TO: Mercedes-Benz Dealer Principals, General Managers, Sales Managers, Service Managers, Parts Managers	FROM: Gregory Gunther, Department Manager, Vehicle Compliance and Analysis, Engineering Services
RE: <b>Emission Modification Notification – [[2020050018]]</b> <b>MY15 ML250 (W166) BlueTEC Update – Emission Modification Category (EMC) #11</b>	DATE: March 17, 2021

Emission Modification Notification			March 17, 2021
Campaign No.:	EMC#	Campaign Desc. :	BlueTEC Update – MY15 ML (W166)
2020050018	11	19P4992009	
<p>This is to notify you of an Emission Modification to update the emission control system on approximately 3,588 Model Year (“MY”) 2015 ML250 BlueTEC (W166) diesel vehicles. Emission Modification information will be visible on the <a href="https://BlueTecUpdate.mbusa.com">https://BlueTecUpdate.mbusa.com</a> website and may generate questions from Owners and Lessees. <b>Affected VINs will be flagged in VMI as “OPEN” on March 17, 2021.</b></p>			
<b>Background</b>			
Issue	Mercedes-Benz USA, LLC (“MBUSA”) is modifying the emission control system on certain diesel vehicles. The Emission Modification for MY15 ML250 BlueTEC (W166) vehicles has been approved by EPA and CARB, and is

Figure 3

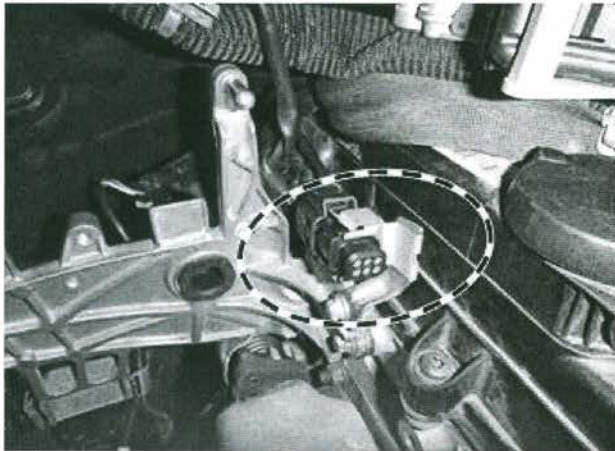
5. Install the electrical end-cap (A 000 545 40 39) (Figure 3) to the engine harness for the oxygen sensor.

**i** The electrical connection of the oxygen sensor *is no longer required!*

6. Install the plug (N 007 604 018 109) and seal (A 021 997 62 45) on the new Combination Box DOC+DPF (Nm 50, Figure 4).

**i** Oxygen sensor is *no* longer required!

Figure 5

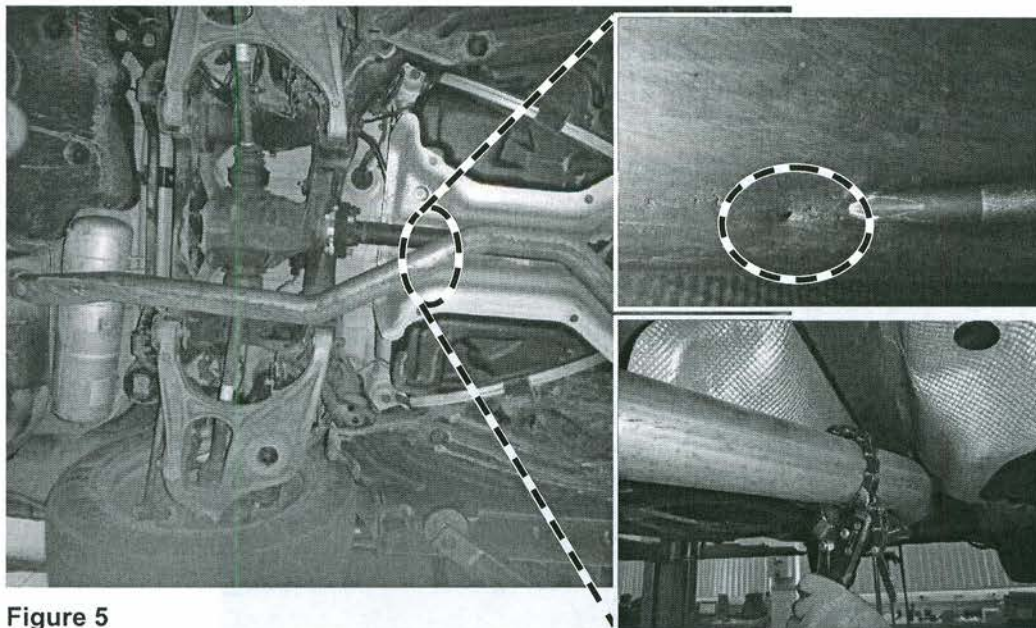
7. Using a chain pipe cutter, cut off the exhaust system tailpipe at a right angle to the muffler at the separating point that is marked by the stamped-in notch (figure 5).

**i** Be sure to support the rear muffler and secure it so that it doesn't fall.

**i** A different tool (such as a saw) may be used for cutting.

**i** **Installation:** Check installation position and unobstructed movement of the exhaust system. The exhaust system must be installed so that it is free of tension. Align the exhaust system if necessary.

Figure 8

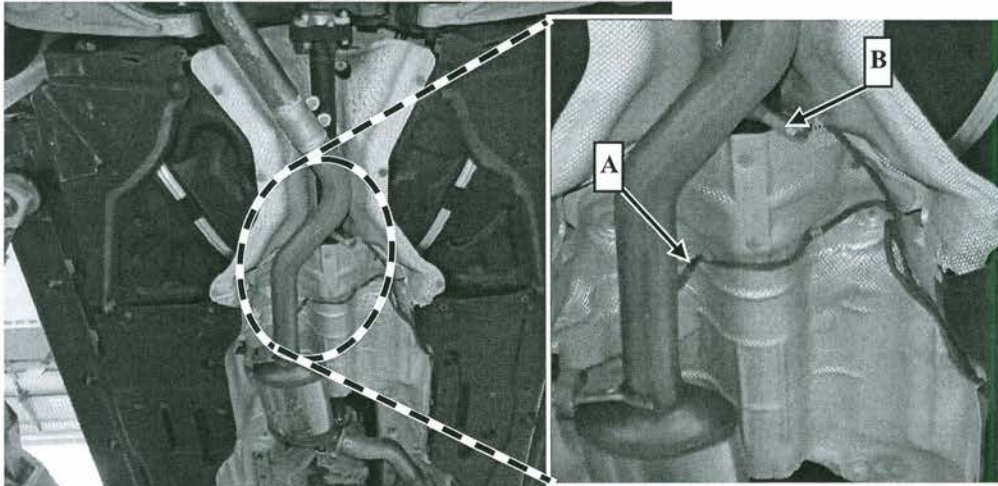
10. Replace NOx sensor A 000 905 58 12 80 (A, figure 8) and particulate sensor A 000 905 10 08 (B, figure 8), rear, on SCR catalytic converter (AR14.40-P-2038GQ).

**i** It is not necessary to carry out the reset routine using XENTRY Diagnosis.

**i** The new sensors are already equipped with paste, hot lubrication.

**i** The pigtail wire at NOx sensor and particulate sensor should be cut for ease of removal and to ensure it is not reused.

Figure 13

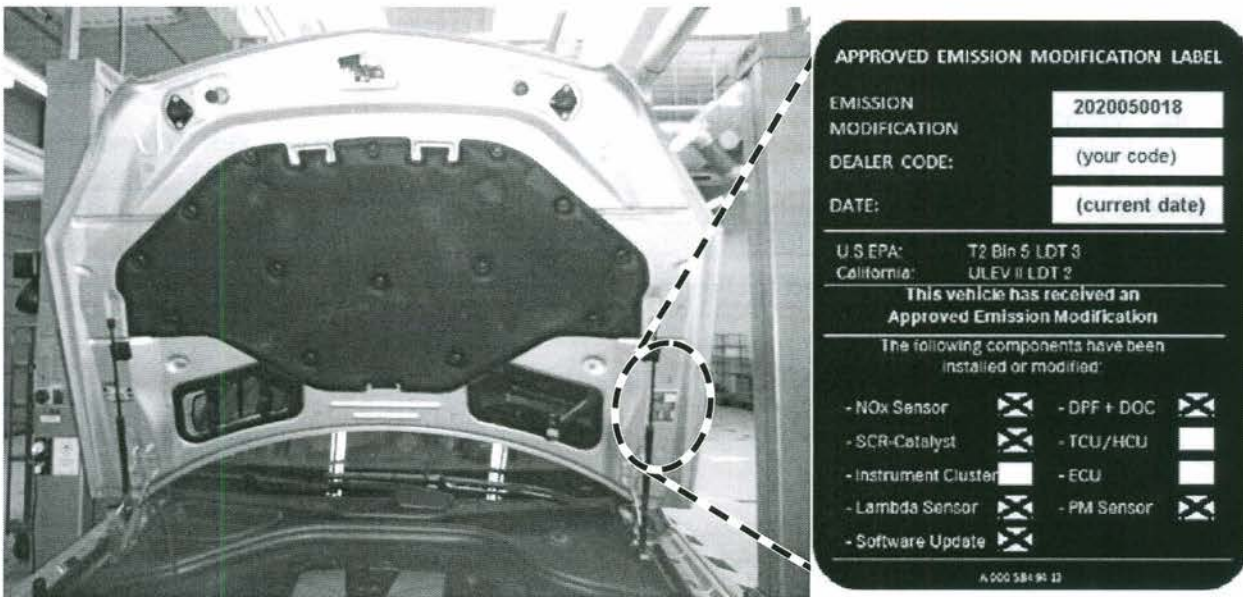
15. Clean the bonding surface of the hood and attach the AEM-label (**Figure 13**).

**i** The fields on the adhesive label must be filled out correctly. Please use black permanent marker. Refer to (**Figure 11**) within the Xentry procedure

**i** The adhesive label can be applied to the hood **while** updating the software for the engine control unit.

**i** **Failure to comply may result in dealer debit and/or possible fines.**
